ADDENDUM NO. 1

Reference: Building 1830 Remodel – Camp Williams
Utah National Guard
DFCM Project No. 08021480

Addendum No. 01

Project: Building 1830 Remodel
Address: Camp Williams
City, State: Riverton, Utah

BUILDING 1830 REMODEL SD-01
CAMP WILLIAMS UTAH NATIONAL GUARD

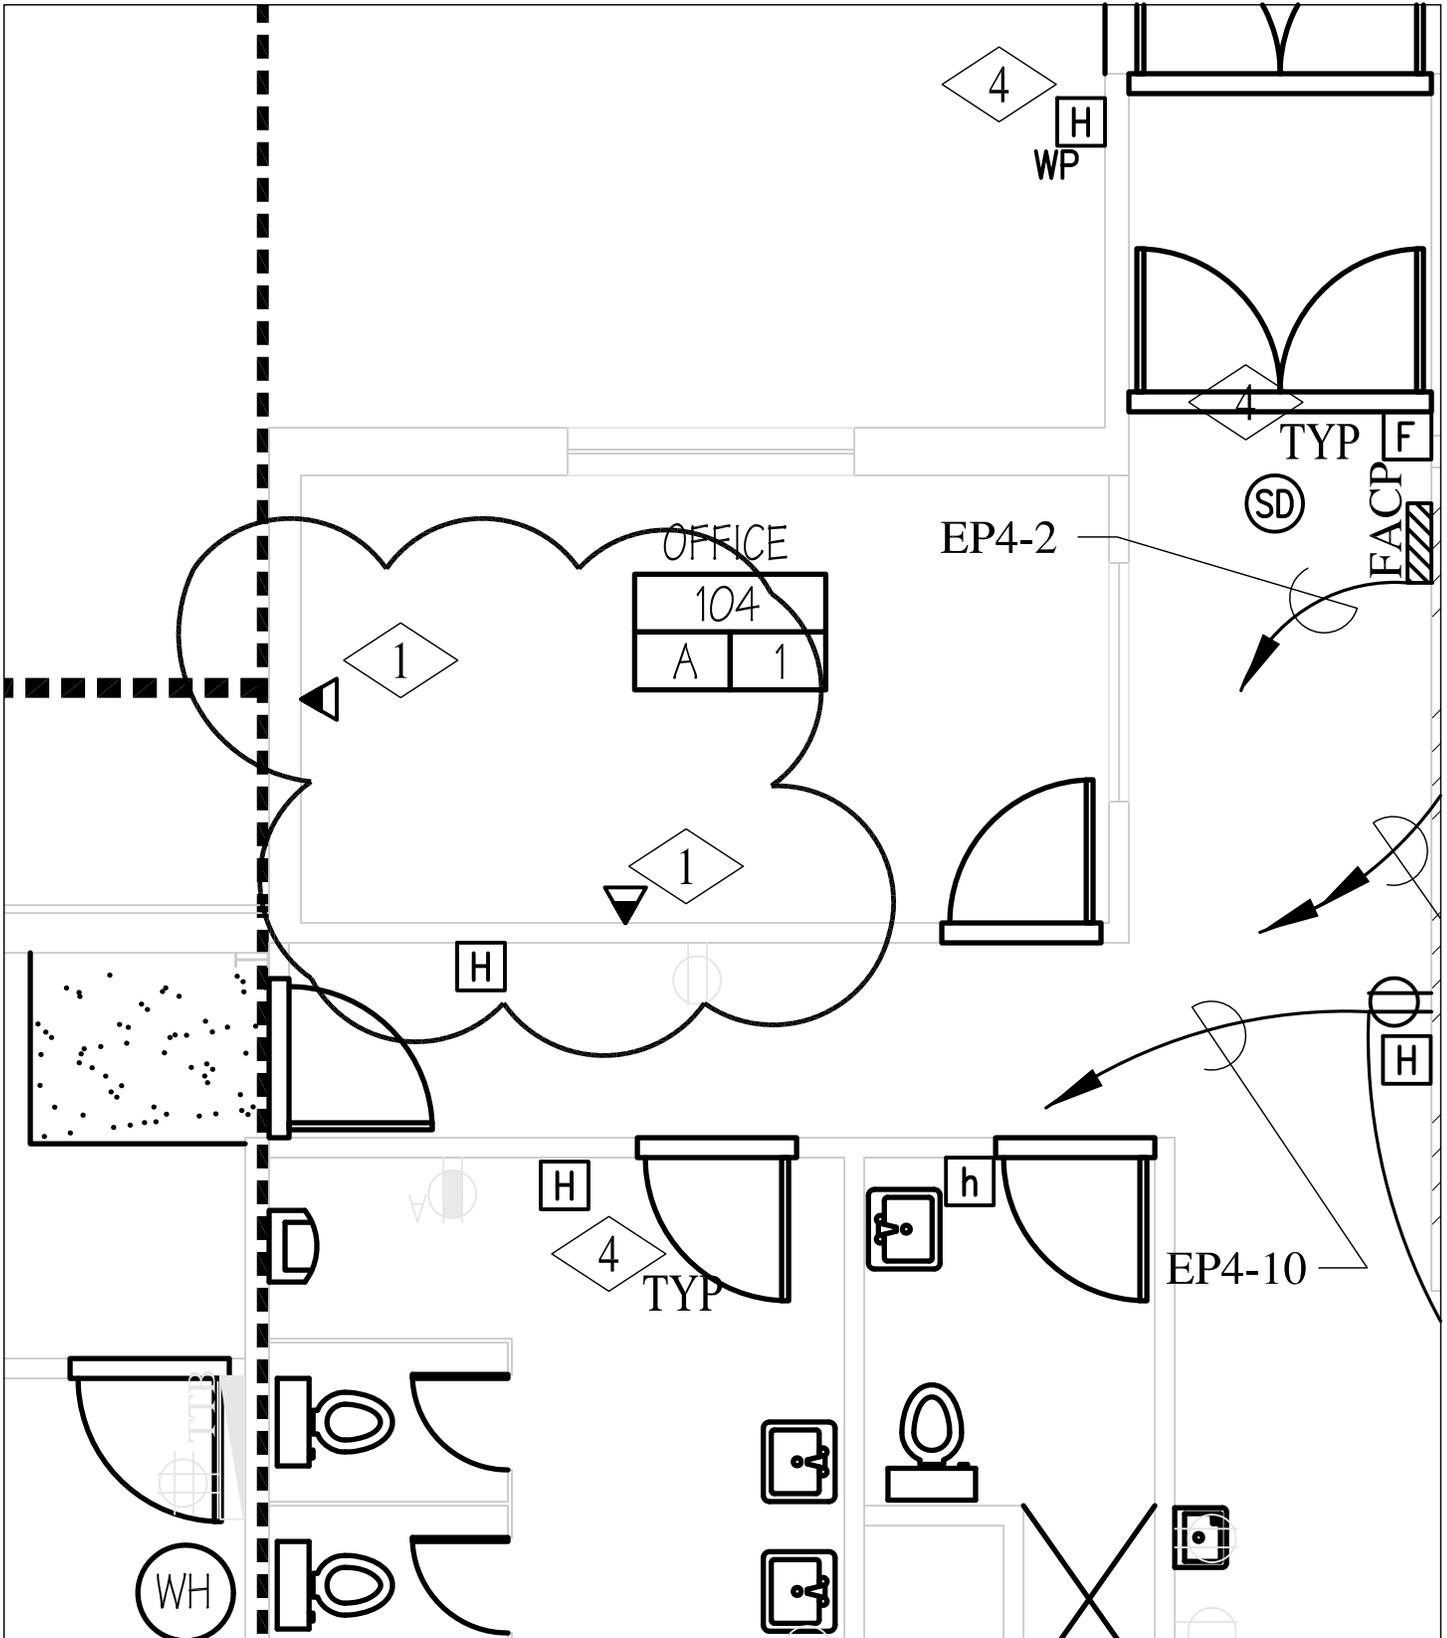
- 1 -15 AE102 **Add** wall hatch type "H" to wall in alternate #2 between grid G + 7'-0" and H along grid 1.
- 1 -16 AE101/401 **Delete** restroom layout on C3/AE101 and A3/AE401 and **add** the revised restroom drawing, see attached drawing SD-01. (The chase walls were removed between the two restrooms and a 6" metal framing wall was added in it's place.)

PROVIDE 6" MTL FRAMING AT 16" O.C. W/5/8" GYP. BD.
EACH SIDE. EXTEND WALL TO UNDERSIDE OF ROOF
DECK OR STRUCTURE. EXTEND GYPSUM BOARD 6"
ABOVE CEILING. SEE DETAIL D6/AE401. PROVIDE
SOUND BATT INSULATION.
